SERVICE INFORMATION NO. SI 20E-006

Rotax Service Bulletin No. SB-912i-008R1 Inspection and/or replacement of the valve push-rod assy

Inspection and/or replacement of the valve push-rod assy., rocker arm left and rocker arm right for ROTAX® Engine Type 912 i, 912 and 914 (Series)

ATA System: 72-30-00 Cylinder head

Fig. 1
Visual inspection

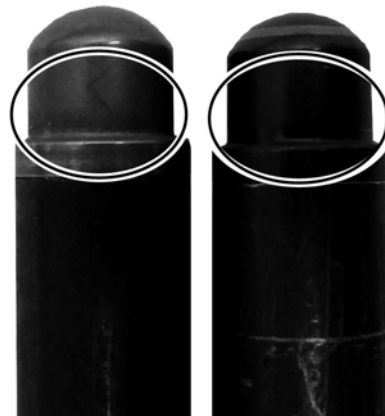
Perform visual inspection of all push-rod ball sockets on all cylinder.

Check for color. See Fig. 1.

Color	Evaluation
Silver surface	Valve push-rod is OK. No further action required for this valve push-rod.
Black surface	Valve push-rod is NOT OK. See section. 3.1.3) Replacement of affected parts.

Fig. 2

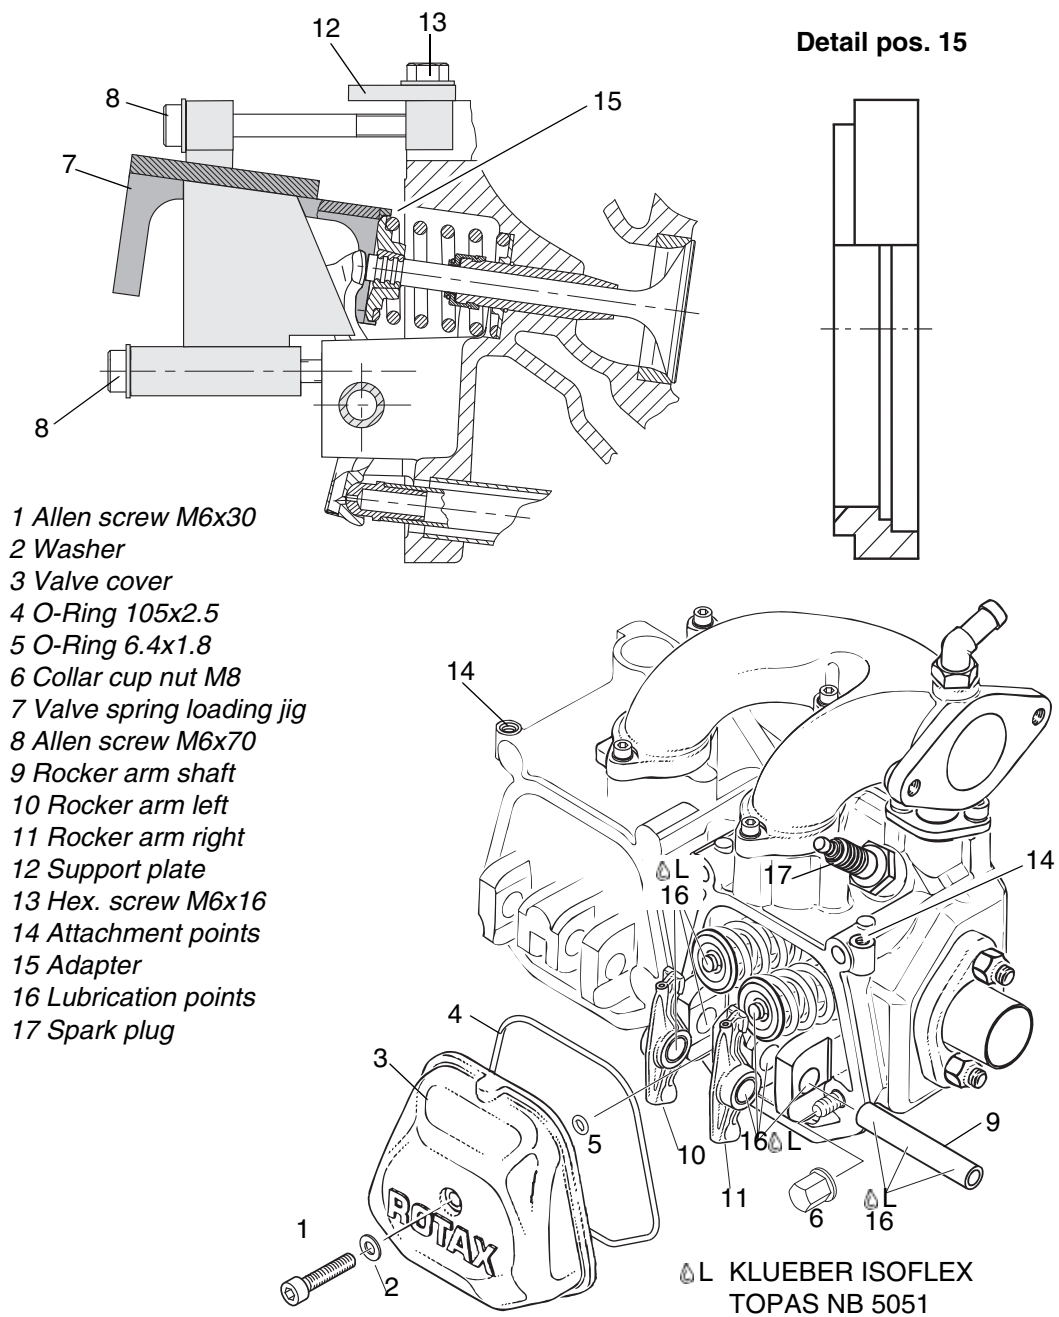
See Fig. 2.

Step	Procedure
1	Loosen Allen screw (1) M6x30 with washer (2) from valve cover (3), and remove it together with large and small O-rings (4) and (5).

See [Fig. 2](#) and [Fig. 3](#).

Step	Procedure
3	Attach the support plate (12) to the valve spring loading jig part no. 877387 (7) with 2 hex. screws (13) M6x16 at the attachment points (14) on the cylinder heads.
4	Put adapters (15) on the valve spring loading jig.
5	Attach the valve spring loading jig on cylinder head and support plate with 2 Allen screws (8) M6x70 and depress both valves with 3 turns.

Step	Procedure
1	Clean the sealing surface of cylinder head and valve cover with a suitable lint-free cloth or equivalent.
2	Insert new O-ring (4) 105x2.5 and O-ring (5) 6.4x1.8 into the valve cover (3).
3	Fit valve cover.

Between the valve covers a gap of min. 0,1 mm (.004 in.) must remain. The covers must not touch each other.

Step	Procedure
4	Tighten the new Allen screw (1) M6x30 with washer (2) to 10 Nm (89 in.lb).

Fig. 3

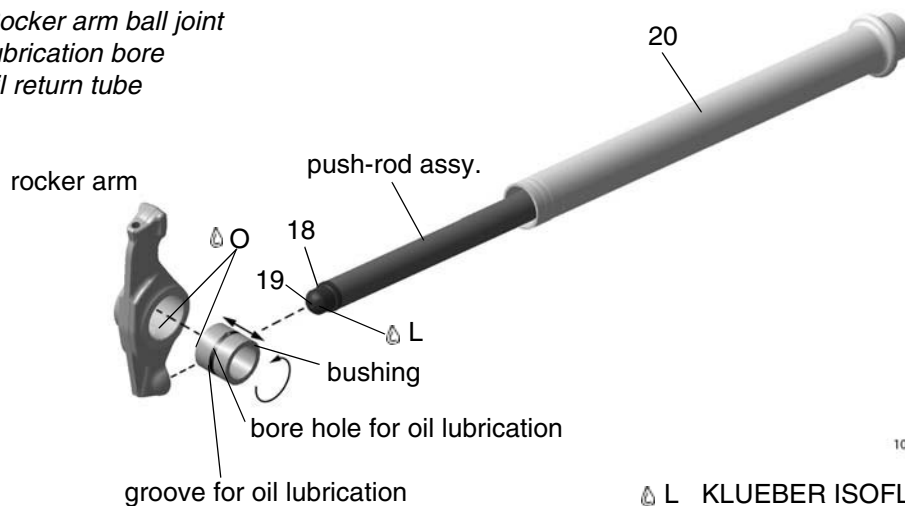
Step	Procedure
6	This will relieve the pressure from both hydraulic tappets. Now the rocker arm shaft (9) may be easily pulled out. Lift out both rocker arms (10) and (11).
7	Replace only affected parts as per section 2.3 . See also Fig. 3 .
8	Apply KLÜBER ISOFLEX TOPAS NB 5051 (16) on both push-rod ball sockets and contact areas of rocker arm and slide push-rod into the oil return tube (20).
9	Check bushing and rocker arm shaft according to latest Maintenance Manual Heavy.
10	Put oil on the rocker arm bushing.
11	Place rocker arm left (10) and rocker arm right (11) in cylinder head, apply KLÜBER ISOFLEX TOPAS NB 5051 (16) on rocker arm shaft (9) and insert it into its bearing support.
12	Loosen valve spring loading jig and support plate.
13	When removing the valve spring loading jig, make sure the adapter rings (15) do not jam on the valve spring retainer.
14	NOTE: Only when you have an Criterion B) Spare parts affected engine and only if engine is equipped with collar cap nuts M8 wrench size 13: Mount collar cap nut (6) according to latest Maintenance Manual Heavy or SI-912-025/SI-914-026/SI-912 i-010.
